# East West Rail Phase 2

### Stage 2 Road safety audit response report

### Offline Highways Passing Places – Package 2 – Oxfordshire (A3 Marsh Gibbon – Compound Access)

East West Rail (Western Section) Phase 2

Drawing Title  
**PASSING PLACE A3\_P\_8  
GENERAL ARRANGEMENT**

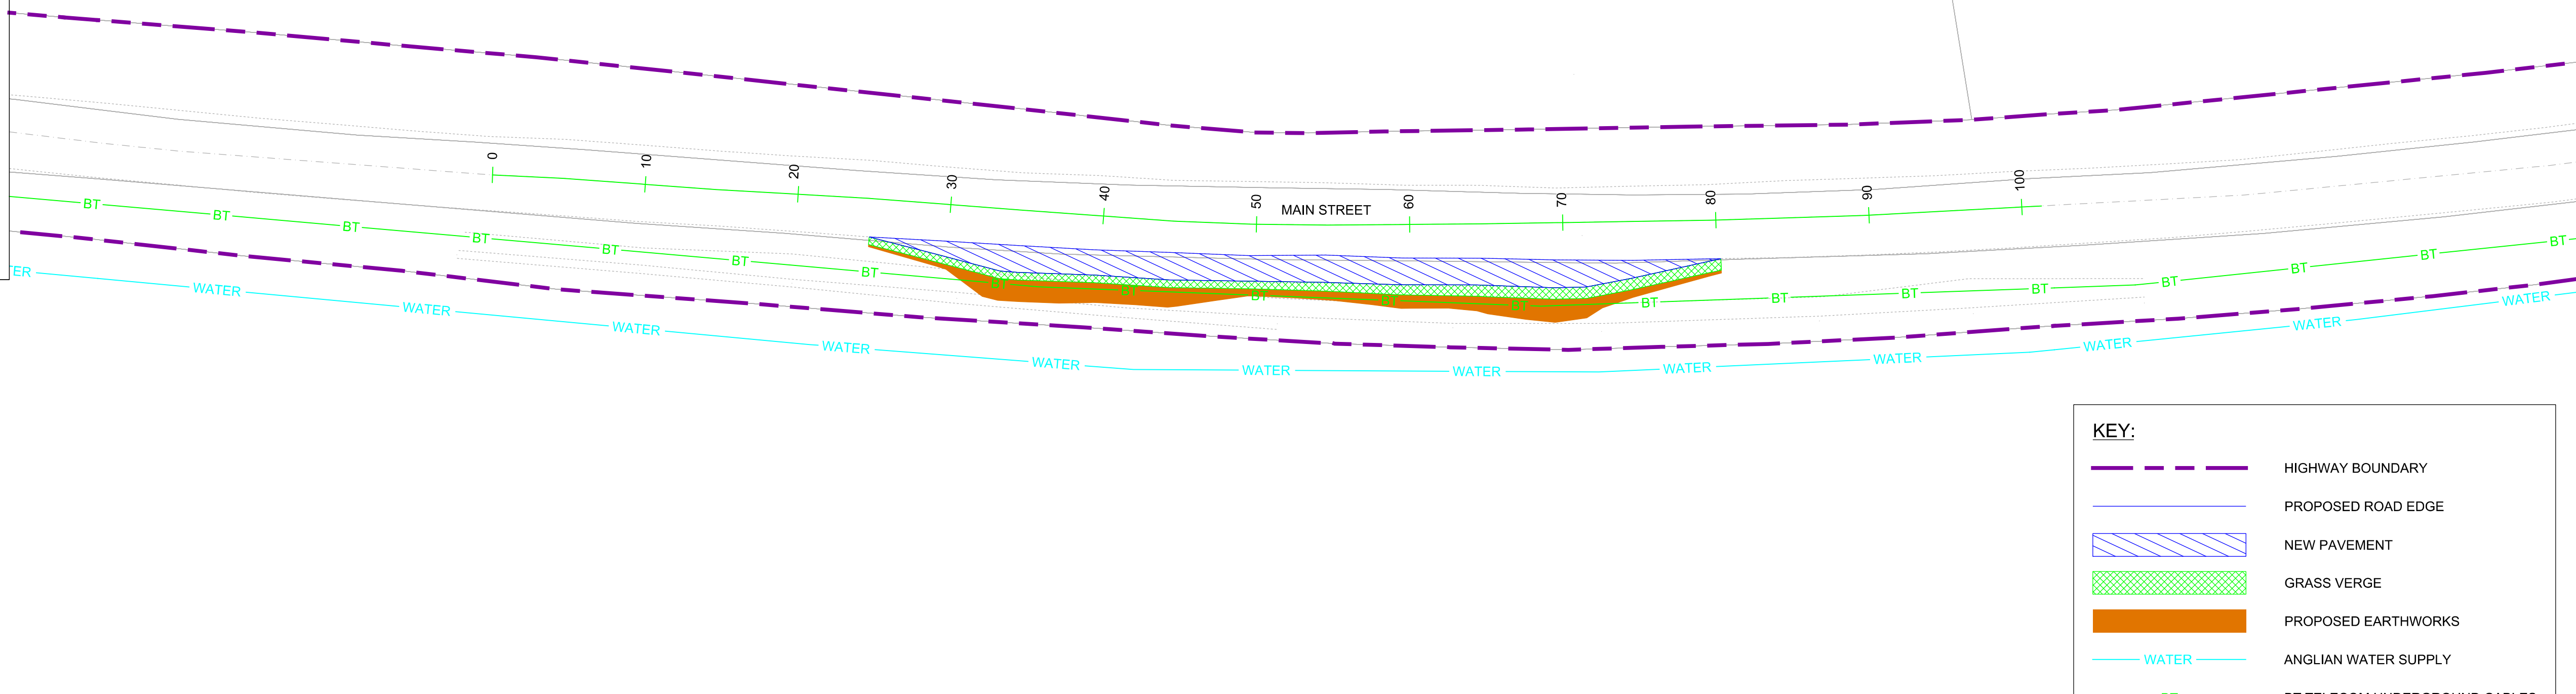
**Location:** Passing Places A2-P-2, A3-P-2, A3-P-3, A3-P-4, A3-P-5, A3-P-6, A3-P-7, A3-P-8, A3-P-9 and A3-P-10.

Passing places are proposed in positions where vegetation may restrict drivers' visibility of the route and the visibility of vehicles using the passing places. With this limitation, drivers of construction vehicles may not be aware that they should wait and might proceed, increasing the risk of side swipe collisions, or the risk of vehicles leaving the carriageway

2.5	<p>Passing Places A2-P-2, A3-P-2, A3-P-3, A3-P-4, A3-P-5, A3-P-6, A3-P-7, A3-P-8, A3-P-9 and A3-P-10. Unnamed Road (towards Mill Road) and Unnamed Road.</p>	<p><b>Driver visibility reduced by vegetation</b>                      Passing places are proposed in positions where vegetation may restrict drivers' visibility of the route and the visibility of vehicles using the passing places. With this limitation, drivers of construction vehicles may not be aware that they should wait and might proceed, increasing the risk of side swipe collisions, or the risk of vehicles leaving the carriageway on narrower sections of carriageway. Additionally, drivers of approaching vehicles may not anticipate the construction vehicle leaving the passing place, leading to side swipe or head on collisions. There is further risk that existing vegetation will encroach into the carriageway increasing the risk of damage to vehicles and HGVs being pushed towards oncoming traffic.</p>	<p>The existing vegetation should be cut back to ensure clear visibility to all traffic signs and to keep the carriageway clear from obstructions.</p>	<p><b>Accept the RSA problem and recommendation made by the RSA team.</b>                      The site clearance drawings include vegetation clearance to achieve required visibility and signage strategy drawings likewise include this provision.</p>	Accepted	Proceed as Design Team Response

PASSING PLACE A3\_P\_8  
EXISTING UTILITIES AND  
SITE CLEARANCE

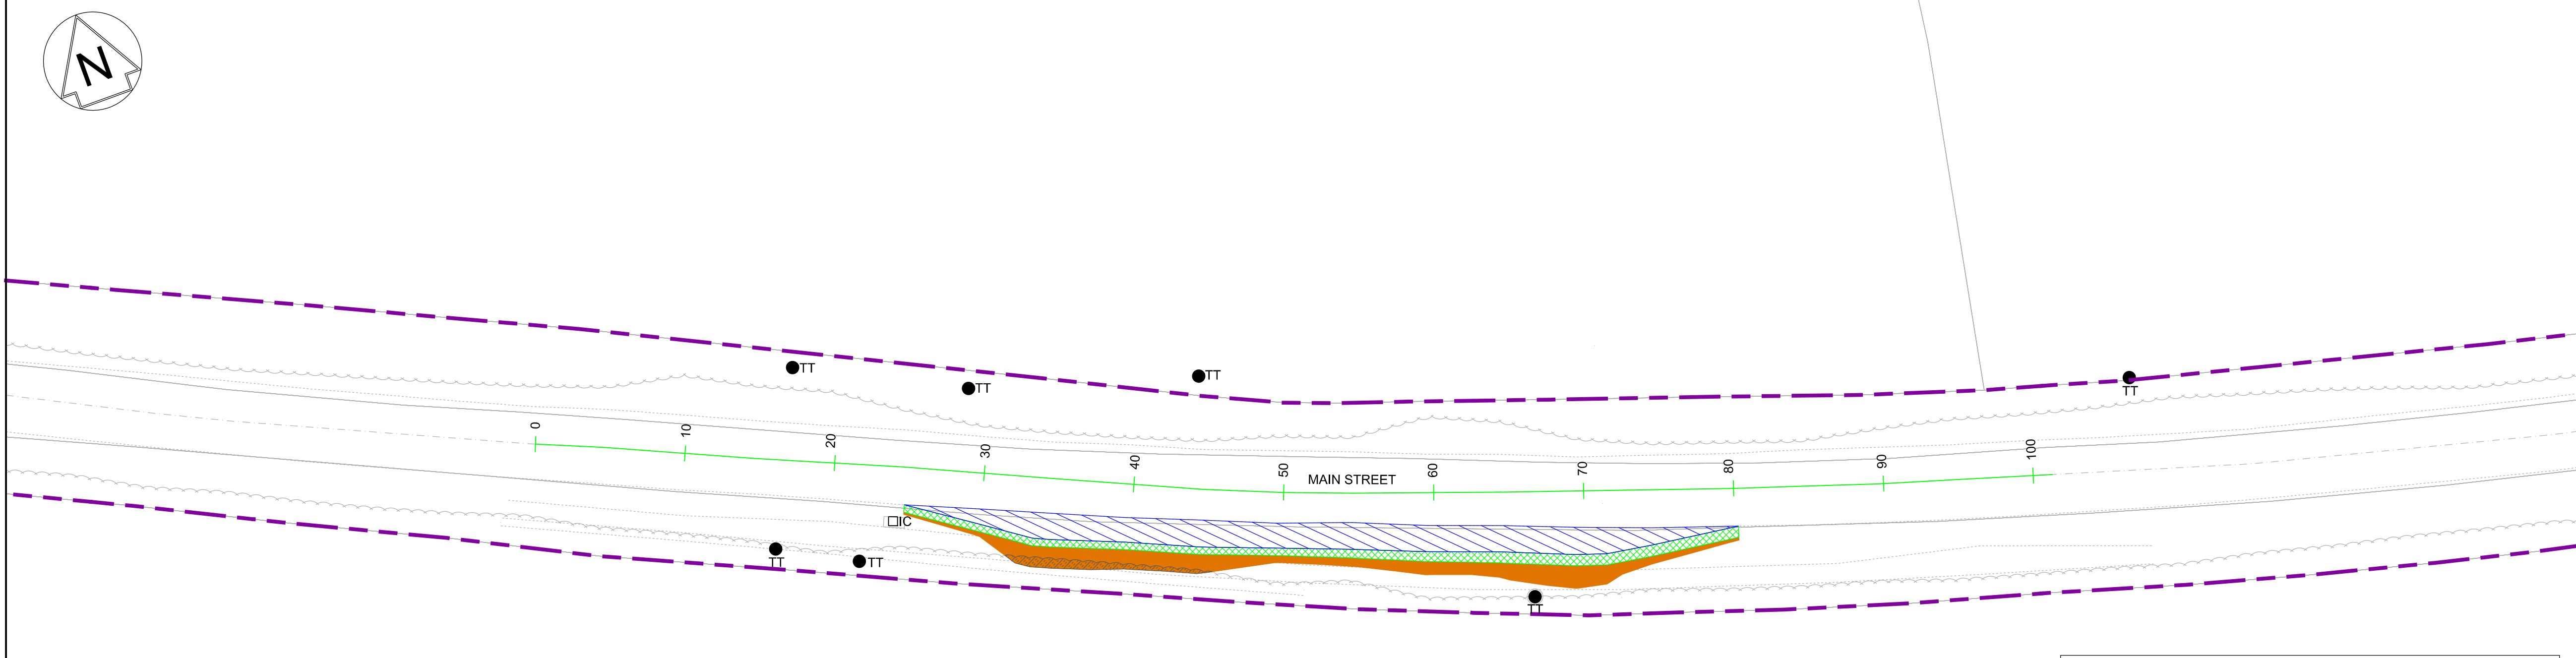
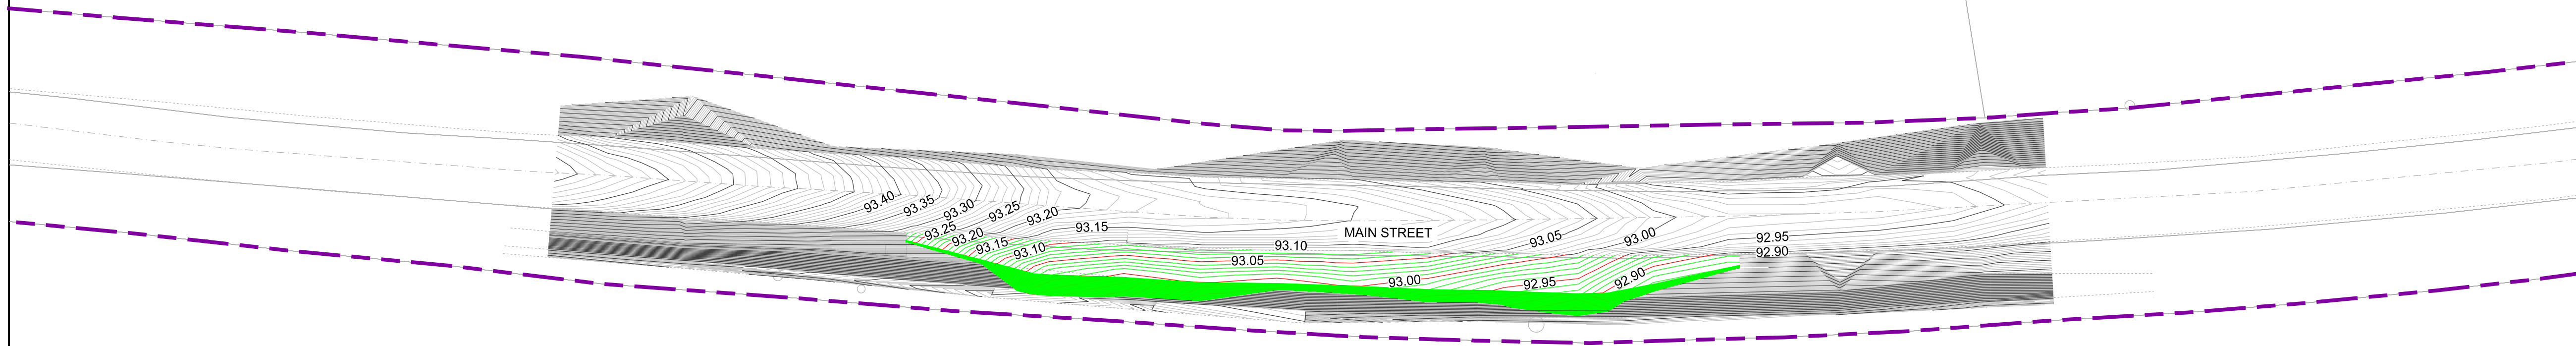
**Location:** Passing Places A3-P-1, A2-P-1, A3-P-2 and A3-P-8.  
Unnamed Road (towards Mill Road).

Driver accessibility to passing places is obstructed by trees, and in some locations, signposts situated in the verge. There is a risk that drivers may collide with the trees on entry/exit of the passing place. Also, drivers' forward visibility is restricted by the location of these trees and as such, drivers of construction vehicles may not be aware that they should wait and might proceed, increasing the risk of side swipe collisions. Additionally, approaching drivers may not anticipate the construction vehicle leaving the passing place, leading to side swipe or head on collisions.

RSA Ref	Location	RSA Problem	RSA Recommendation	Design Team Response	Network Rail Response	Agreed RSA action
2.1	Passing Places A3-P-1, A2-P-1, A3-P-2 and A3-P-8. Unnamed Road (towards Mill Road).	<b>Obstructions in verge increase risk of collision</b> Driver accessibility to passing places is obstructed by trees, and in some locations, signposts situated in the verge. There is a risk that drivers may collide with the trees on entry/exit of the passing place. Also, drivers' forward visibility is restricted by the location of these trees and as such, drivers of construction vehicles may not be aware that they should wait and might proceed, increasing the risk of side swipe collisions. Additionally, approaching drivers may not anticipate the construction vehicle leaving the passing place, leading to side swipe or head on collisions.	Obstructions should be removed from the verges.	<b>Accept the RSA problem and recommendation made by the RSA team.</b> The site clearance drawings note that vegetation clearance shall be undertaken to provide suitable visibility. There is also a note for the lifting of tree crowns to provide 5m clearance above ground level to the back of the proposed verge.	Accepted	Proceed as Design Team Response
